# ADA Curb Ramp New Construction Inspection Form (Perpendicular)

Nw Jackson school rd

24952.54

West union rd

## PERPENDICULAR RAMP (PR)

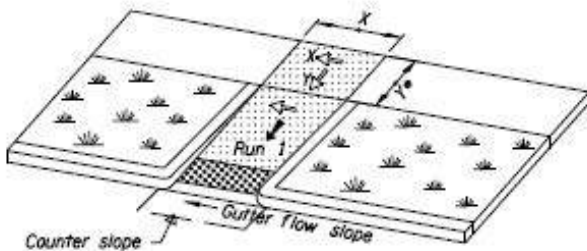
IITD tool joint in turn space ICRR
